RECALL 24V325 REMEDY INSTRUCTIONS

Make(s): AURORA
Model(s): ART26BHS
Model Year(s): 2024

Concern:
The breakaway switch may not be correctly wired to constant hot. This condition may lead to the failure of the brake-away switch to activate in an emergency.

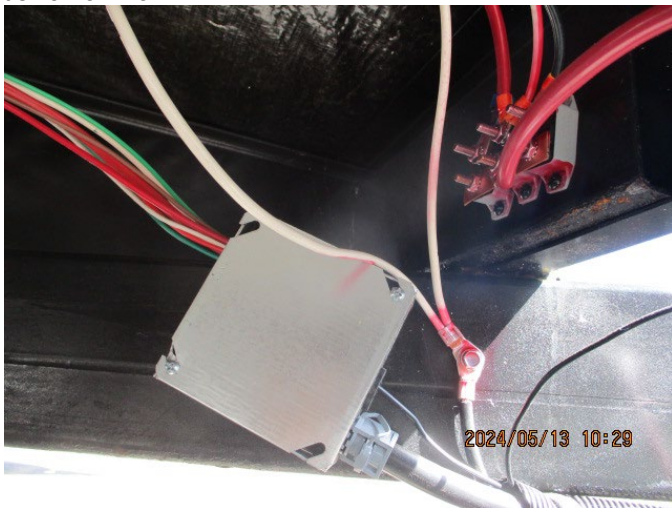
STEP 6: INSTALL THE BREAKAWAYS BLACK WIRE WITH NEW RING TERMINAL TO THE CONSTANT HOT (FROM THE BATTERY);

- TIGHTEN THE NUT BACK DOWN ON THE CONTACT HOT SIDE;
- REINSTALL THE BATTERY DISCONNECT SWITCH COVER;

NEWLY ROUTED SWITCH
